**TOWN OF LOS GATOS
PLANNING COMMISSION AGENDA
APRIL 08, 2026
110 EAST MAIN STREET
TOWN COUNCIL CHAMBERS
7:00 PM**

3. Consider a Request for Approval to Demolish an Existing Single-Family Residence and Construct a New Single-Family Residence on Property Zoned R-1:8. **Located at 16724 Chirco Drive.** APN 424-21-025. Architecture and Site Application S-25-002. Categorically Exempt Pursuant to CEQA Guidelines Section 15303: New Construction or Conversion of Small Structures. Property Owner/Applicant: Zahra Kassam. Project Planner: Erin M. Walters.

DATE: April 3, 2026
TO: Planning Commission
FROM: Joel Paulson, Community Development Director
SUBJECT: Consider a Request for Approval to Demolish an Existing Single-Family Residence and Construct a New Single-Family Residence on Property Zoned R-1:8. **Located at 16724 Chirco Drive.** APN 424-21-025. Architecture and Site Application S-25-002. Categorically Exempt Pursuant to CEQA Guidelines Section 15303: New Construction or Conversion of Small Structures. Property Owner/Applicant: Zahra Kassam. Project Planner: Erin M. Walters.

Chirco Drive Residence
Custom One-Story Home
16724 Chirco Dr
Los Gatos, CA 95032
December 9, 2025

FRONT (NORTHEAST) ELEVATION

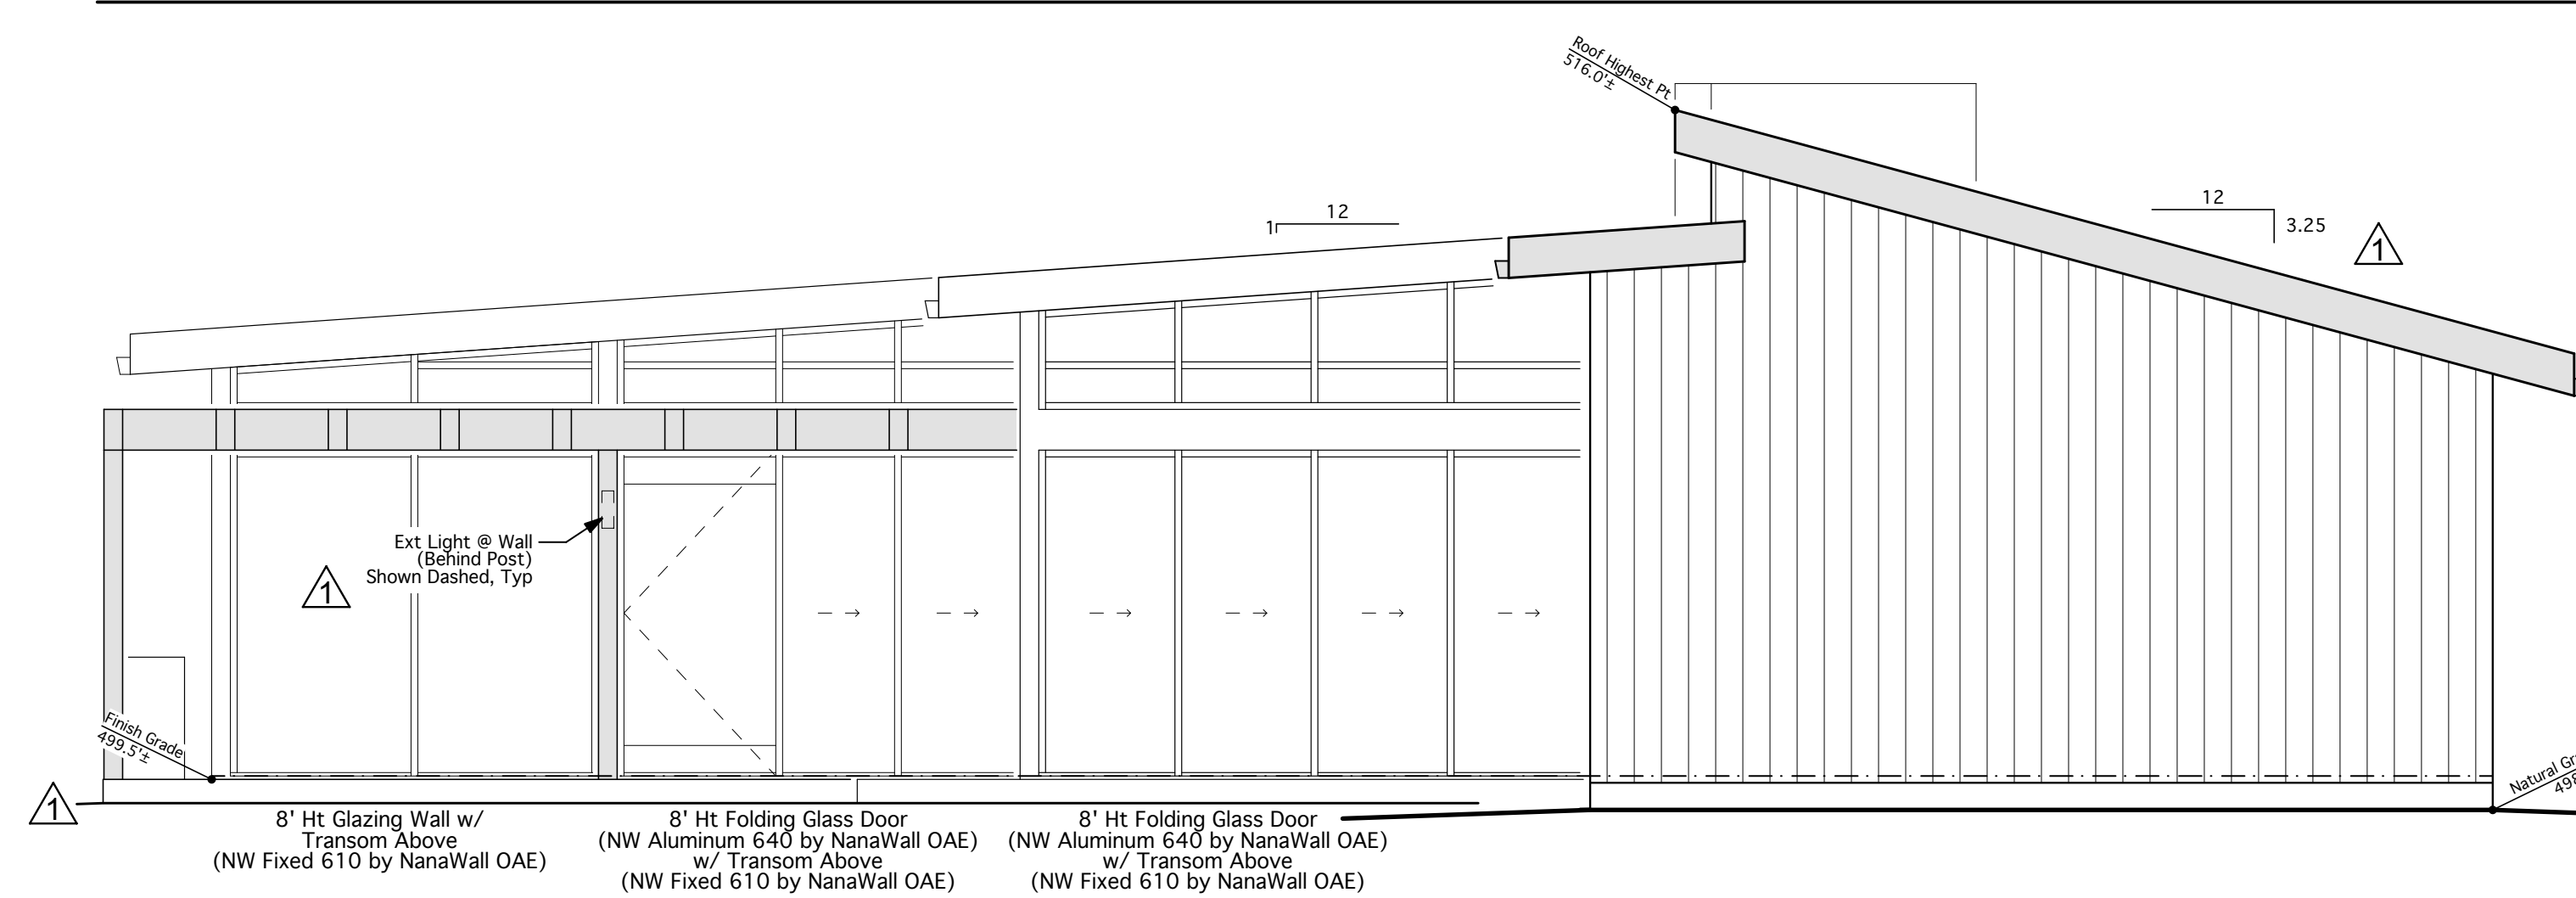
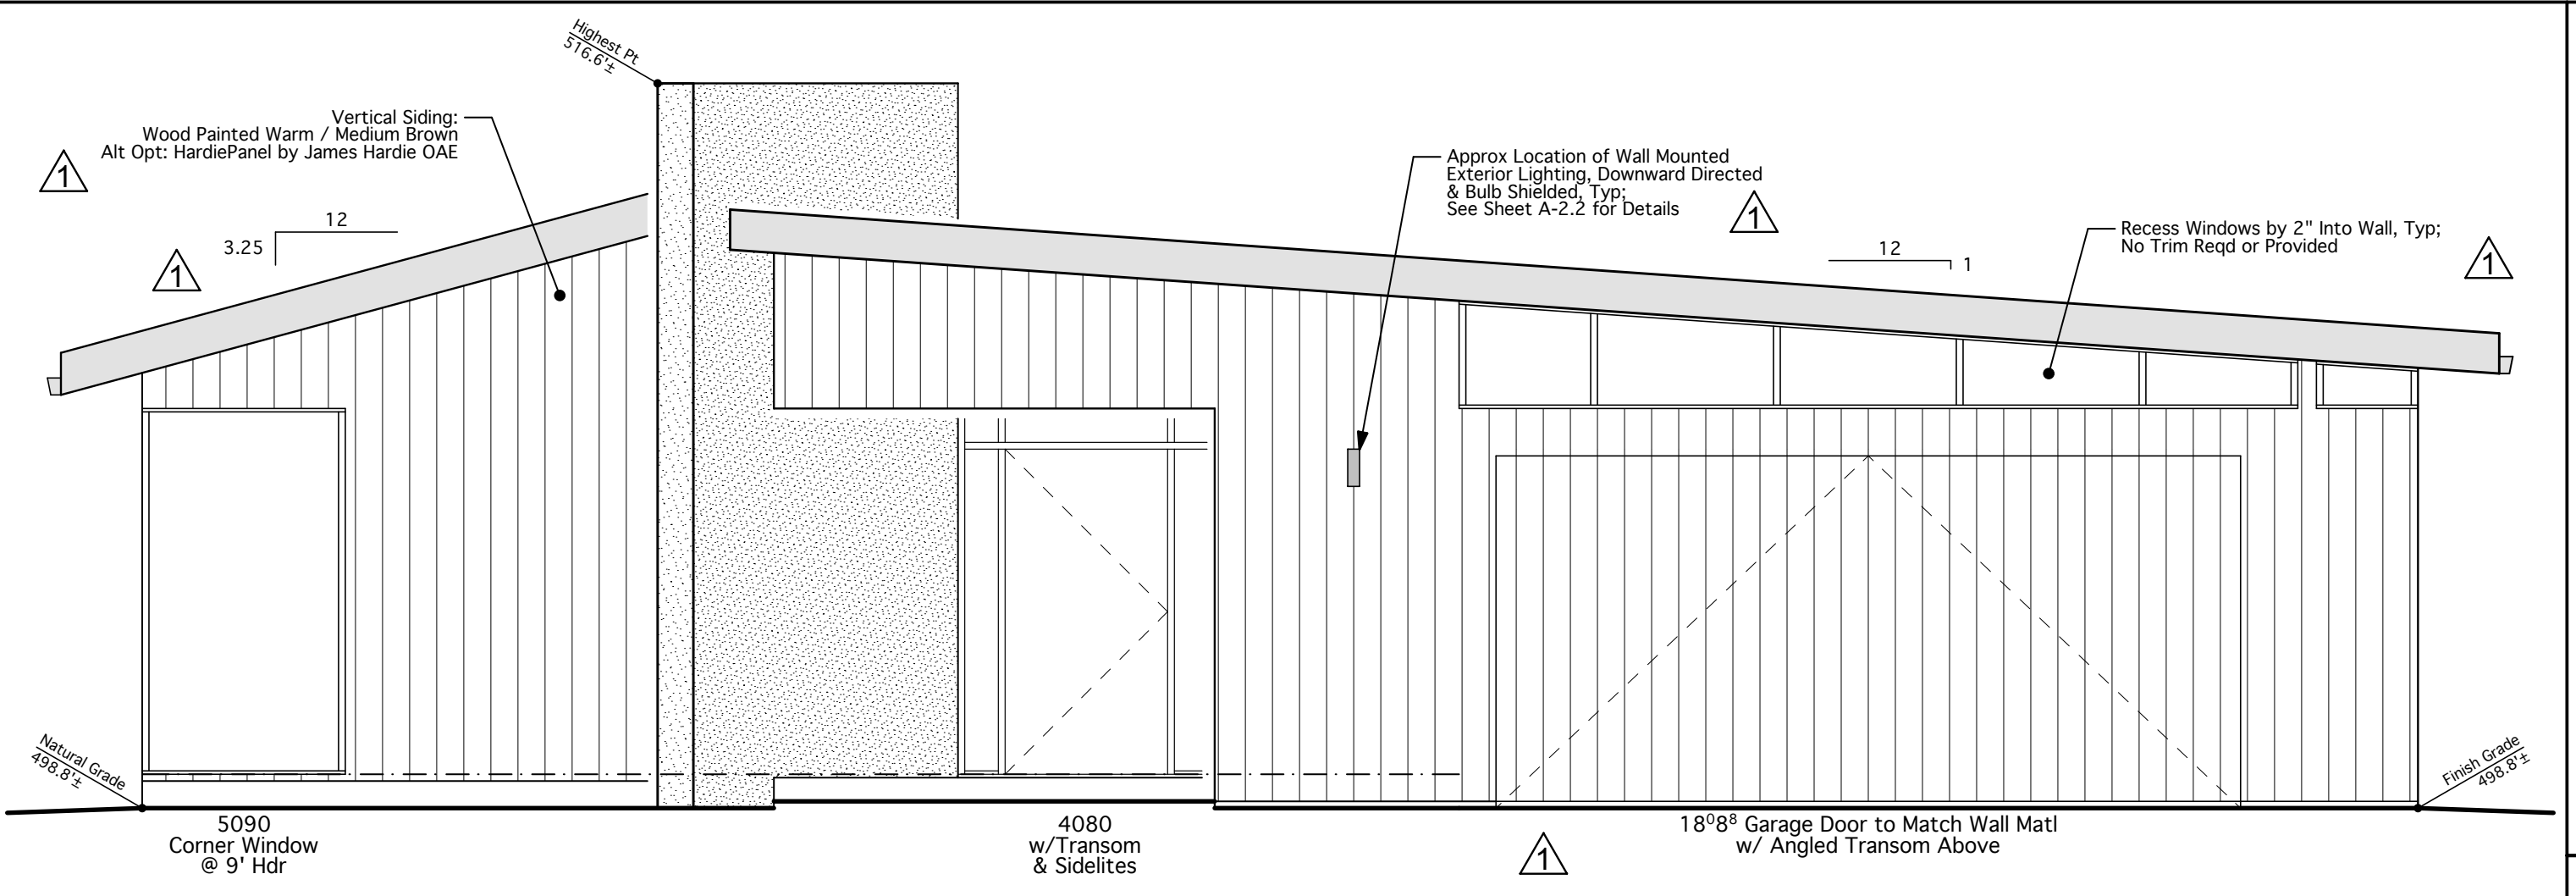
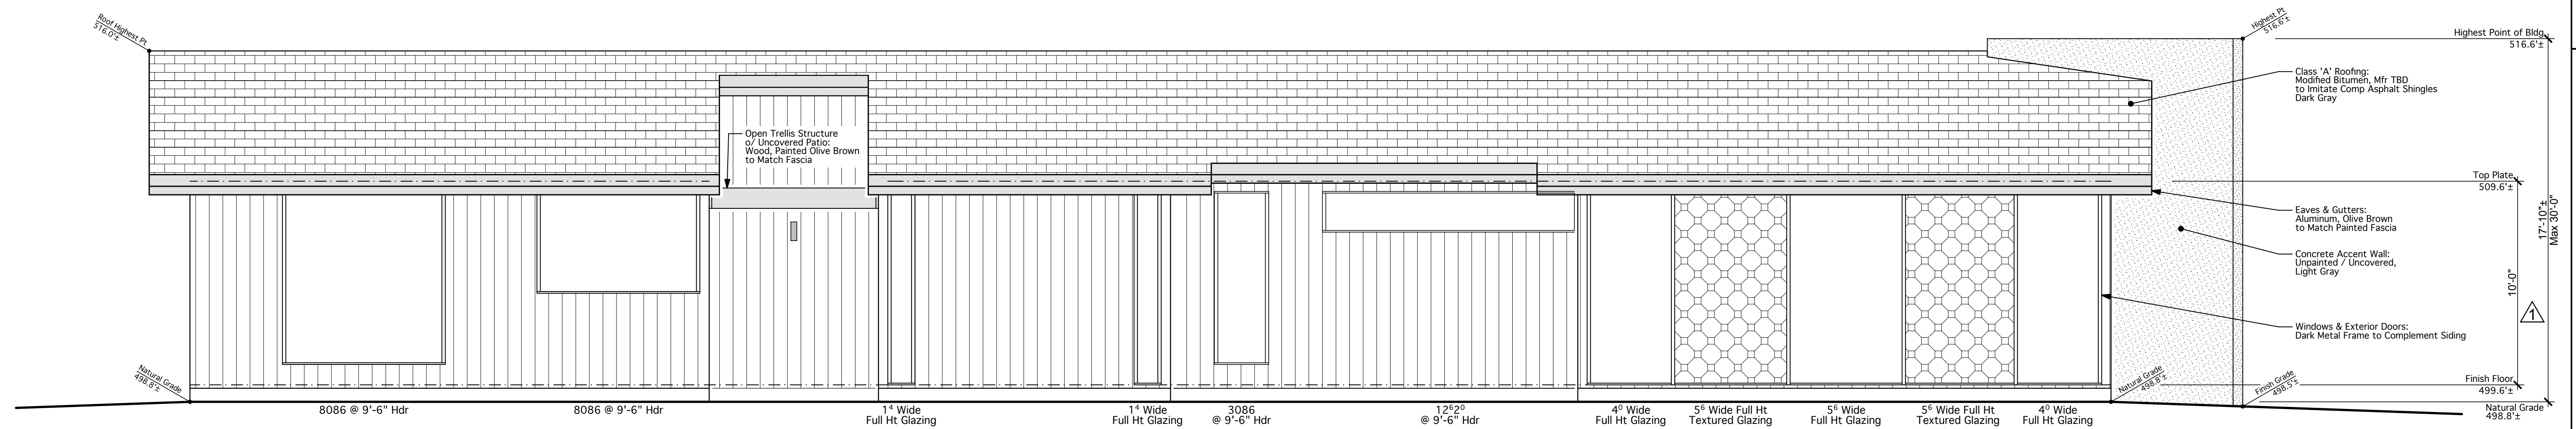
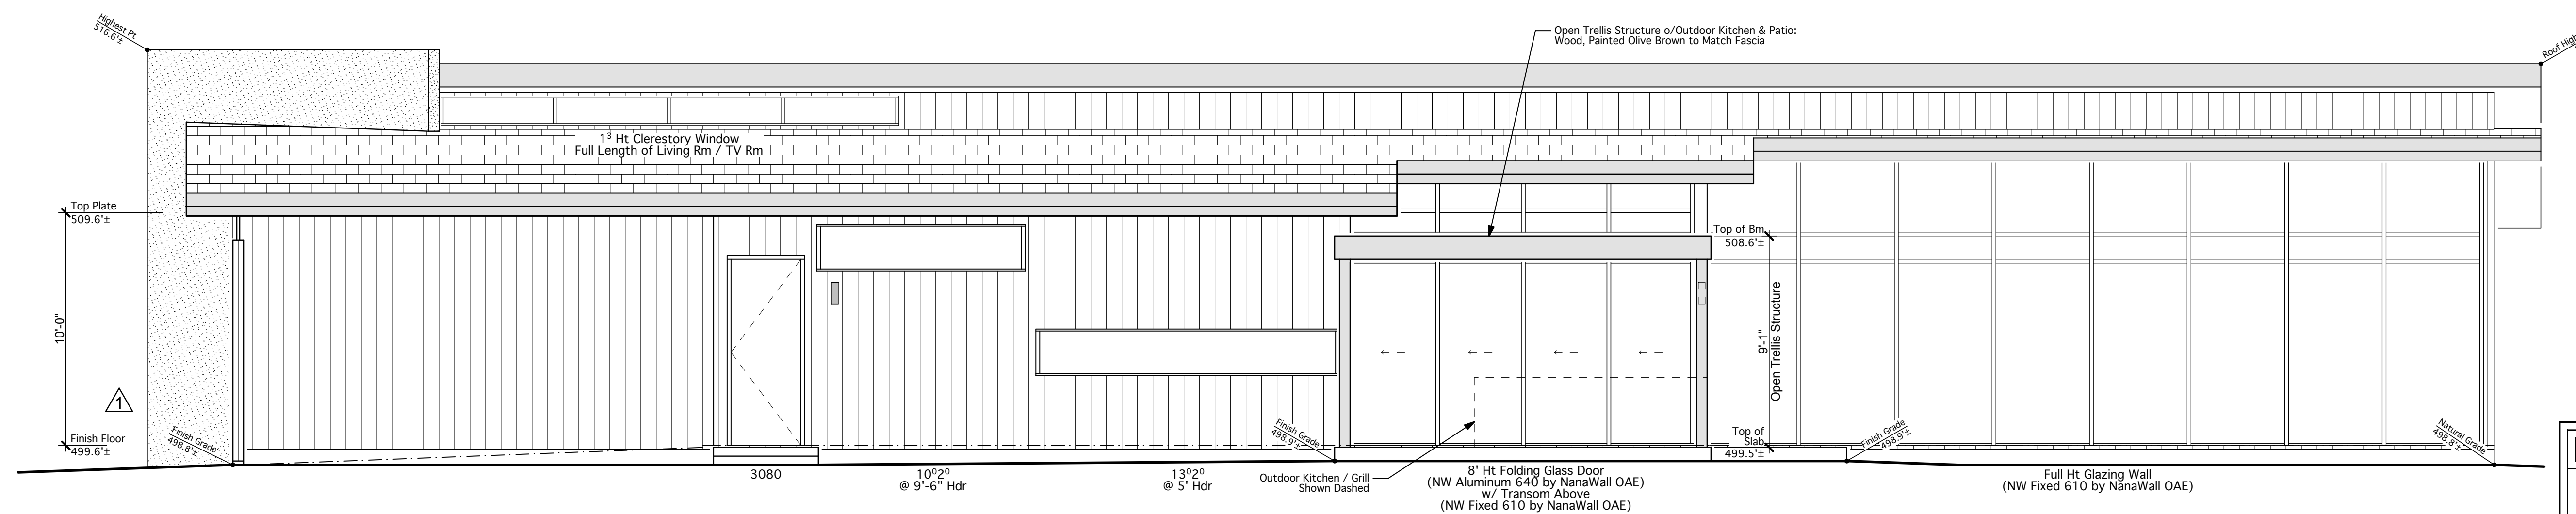
The Town's Consulting Architect reviewed the revised plans on January 14, 2026, and noted that the applicant had made several changes in response to the previous recommendations contained in the review letter of last February (Exhibit 9). The Consulting Architect noted that the changes have been positive, but may not totally address the issue of neighborhood compatibility as set forth in the Town's Residential Design Guidelines. The proposed home is designed in a Contemporary Style. While a home in that general style might be designed to fit into its immediate neighborhood context, this specific design may be difficult to reconcile with several of the Town's Residential Design Guidelines.

The Town's Consulting Architect further stated that the applicant has expressed their intent to model the new home after the Eichler Style. While not common in Los Gatos, it is a significant style in some other nearby Peninsula cities. While diversity is acceptable and desirable, it does not relieve the project from meeting the intent and detail of the Residential Design Guidelines.

6. Add wood trim to all windows, consistent with Residential Design Guideline 3.7.4 or recess the windows from the adjacent wall facade.

Applicant's Response: Left side slope has been increased slightly to complement the adjacent roofline. We would like to maintain the asymmetrical contrast as an important element of contemporary design.

Applicant's Response: Left side eave has been lowered from 11.5' to 10' top plate.

Applicant's Response: Windows are now noted as recessed by 2" with no trim.

Applicant's Response: We prefer warmer tones over the cooler gray/white of Eichler examples. As such, the house color has been updated to a warm brown based on neighboring homes.
